National Fire Protection Association

MEMORANDUM

TO: NFPA Technical Committee on Fire Pumps
FROM: Elena Carroll, Administrator, Technical Projects
DATE: November 7, 2011
SUBJECT: NFPA 20 ROC TC Letter Ballot (A2012 Cycle)

Figure A.4.19.2.1 Series Fire Pump Unit with Discharge from First Pump Feeding the Low Zone Fire Protection Systems

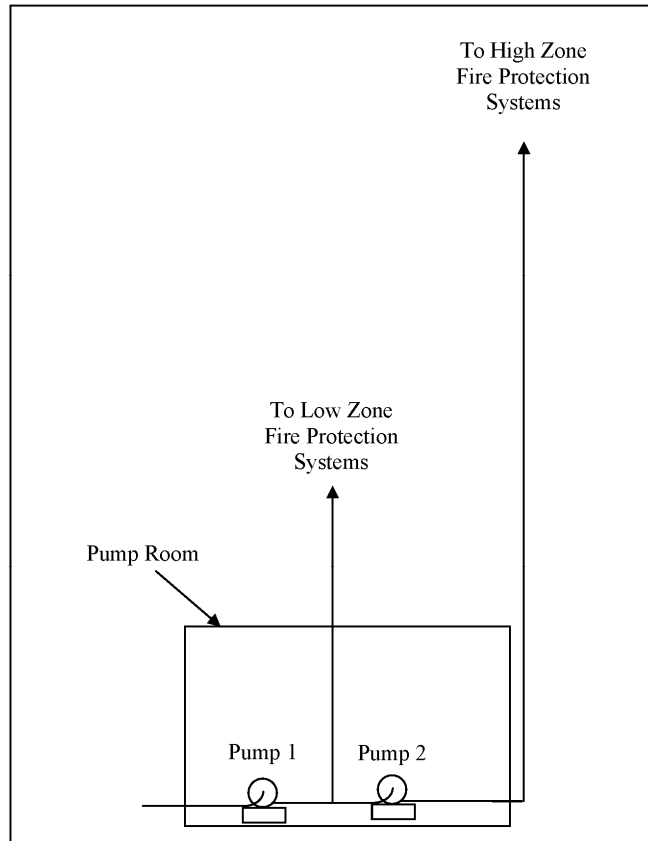
High Rise Task Group Recommended Committee Comment on Series Pumps

A.4.19.2.1 Where pumps are installed in series and are located in the same pump room, the discharge pressure from the second (or third) pump is typically at a pressure that is too high for the outlets on a fire sprinkler or standpipe system on the lower floors of the building. Rather than use this high discharge pressure with pressure reducing valves, it is a common, and accepted practice, to take the fire protection supply from the discharge of the preceding pump through a connection between that pump and subsequent pump(s) as shown in Figure A.4.19.2.1

The combination of a flooded suction condition for the second (or even third) pump, even if the first (or second) pump does not start along with improved communication and protected interconnection controls between pumps and controllers in separate pump rooms creates an acceptable condition under which pumps can be located in separate pump rooms, even when they are a part of a series fire pump unit, as long as the communication and circuit protection requirements are followed.

This action supersedes the actions taken in proposal 20-46 and 20-47.

FIGURE A.4.20.1.2(a)

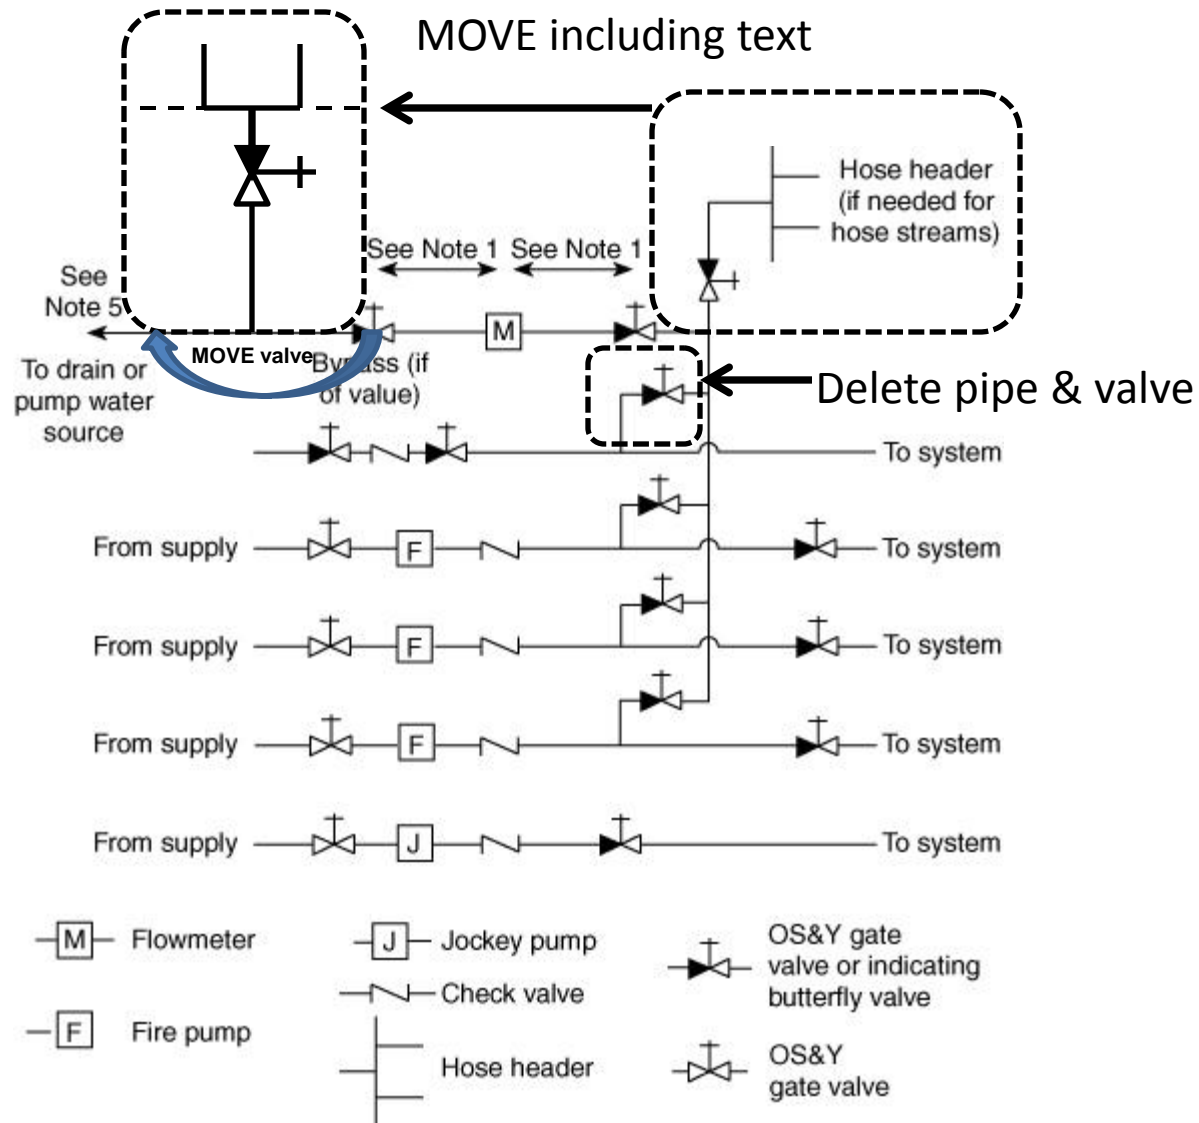
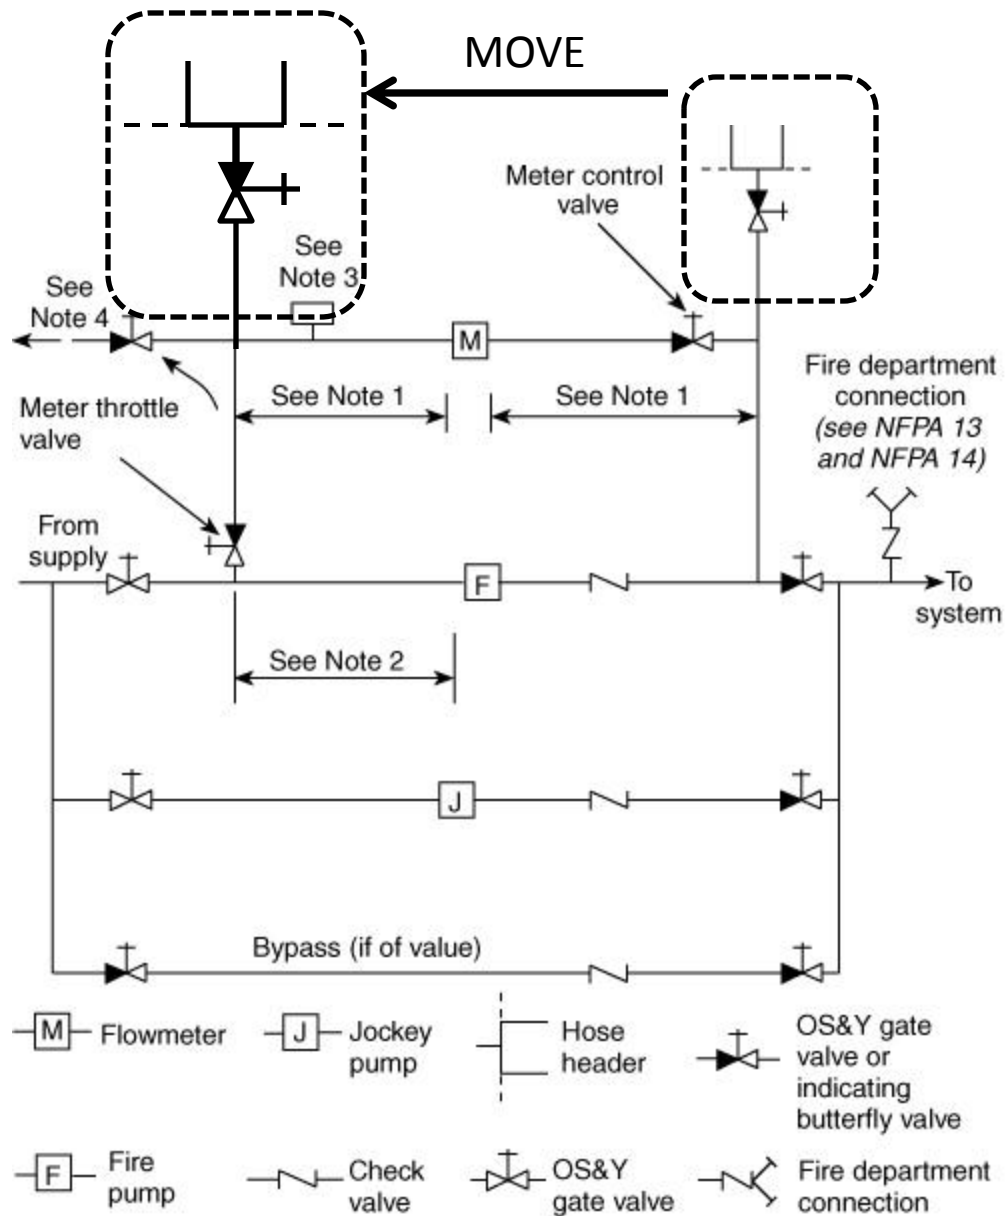
Recommendation: Request the committee to revisit this Proposal and re-instate the submitters proposed New Section 4.20.2.10 (New) and subsequent proposed changes for Annex material in Figure A.4.20.1.2(a) and A.14.2.5.2.3. All proposed wording to be as submitted.

Modify Figure A 4.20.1.2 (a) should be modified to show a test header as an option.

Substantiation: NFPA 25 (Section 8.3.3.1.2.3) is very clear that testing to verify the performance of pump through means other than the flow meter is required at a minimum of once every three years. It stands to reason then that a means needs to be provided in the design stage to accommodate this requirement. Utilizing a test header is generally the most practical and efficient means to accomplish this. This comment is being submitted by the Tyco Codes and Standards Sprinkler Task Group.

Committee Statement: 1. A means needs to be provided in the initial installation to verify the accuracy of the flow meter.
2. The annex language covers design considerations. Once you start testing you are stuck with what was designed.
3. Section 4.20.2.1.1 does not track very well with section "4.20.2.1 –Testing Devices". Also the heading on section 4.20.2.1 violates the manual of style and gives the appearance that sections 4.20.2.2, 4.20.2.3, etc. are subordinate to 4.20.2.1.

Committee Statement: See committee action on 20-31 (Log#69).

20-121 Log #40
(Figure A.4.14.6)

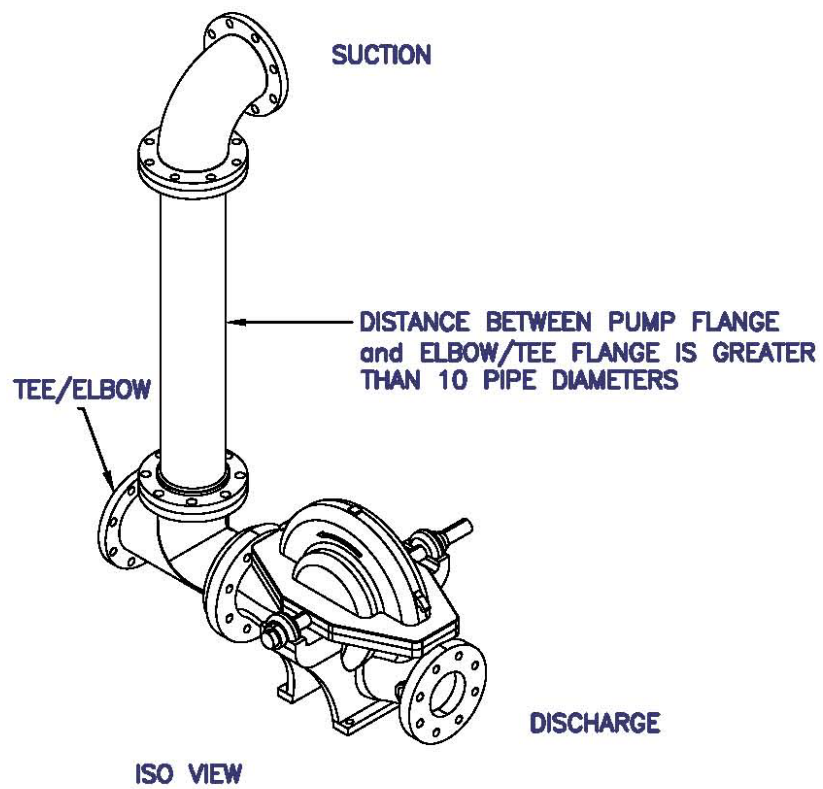
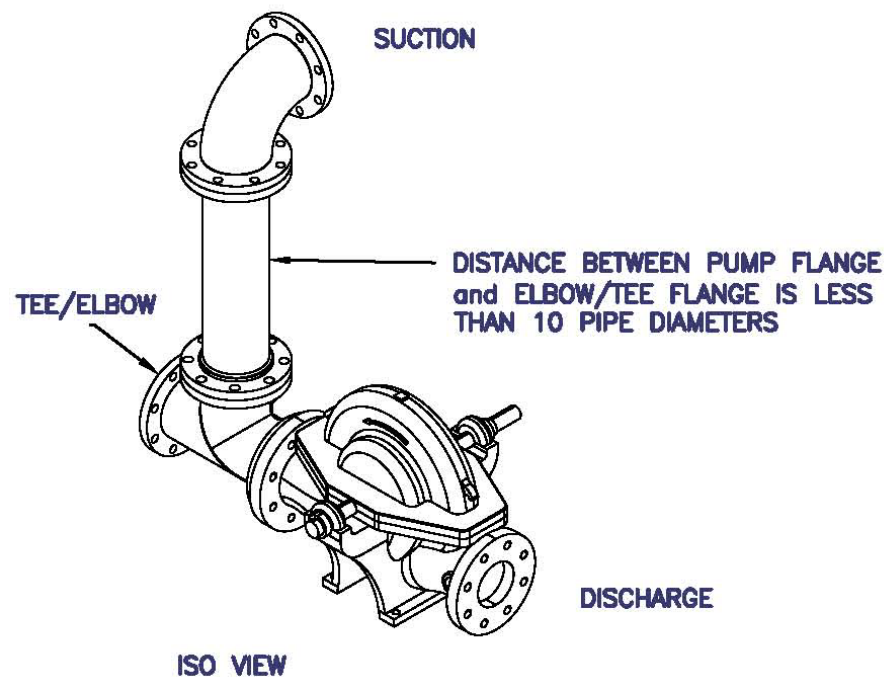
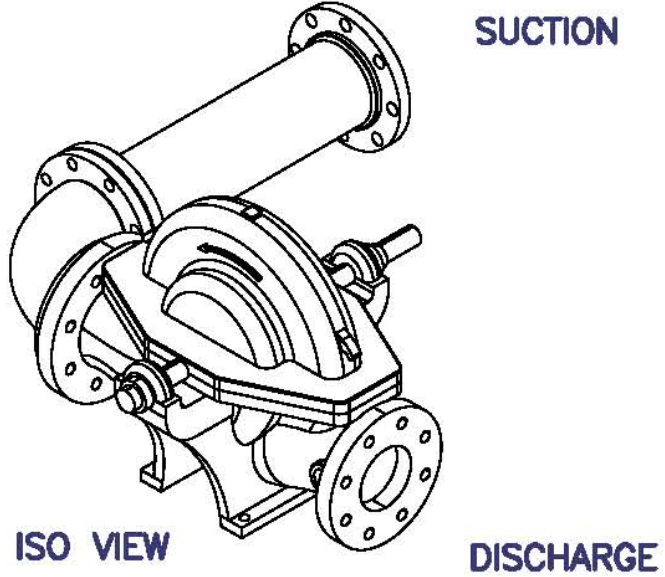
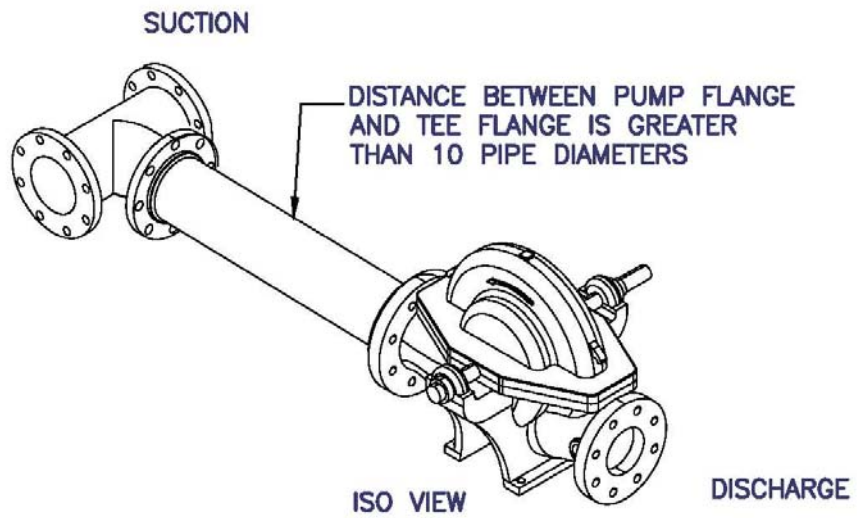
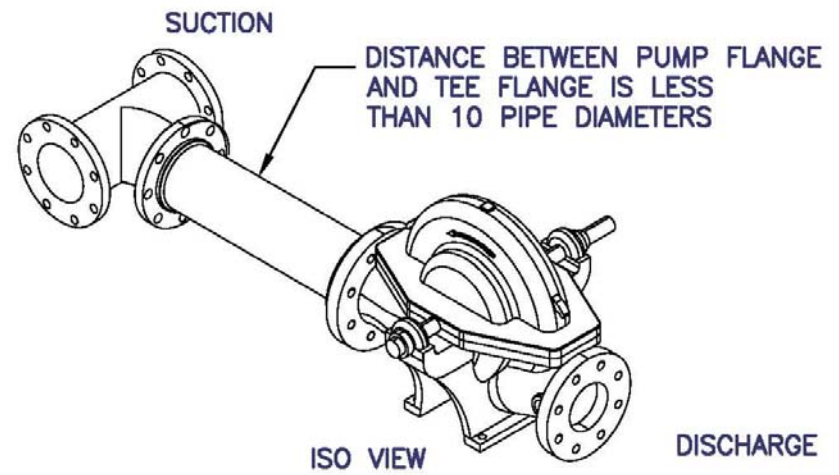
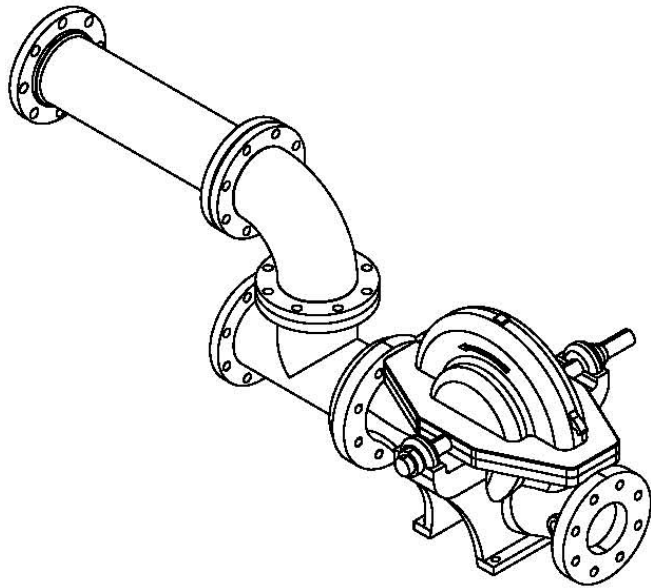
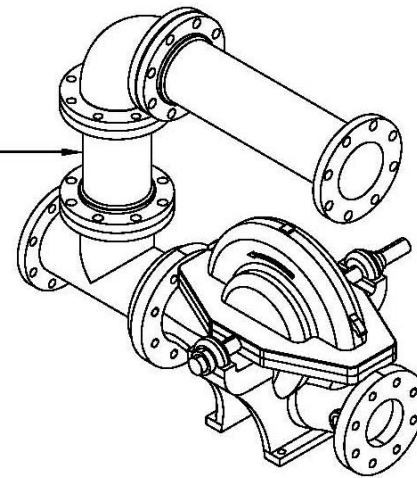
Move annex section A.4.15.9.3 to the body of the document and make section 4.15.9.4 to read as follows:

~~A.4.15.9.3~~ 4.15.9.4 The friction loss through a low suction throttling valve in the fully open position must shall be taken into account in the design of the fire protection system.
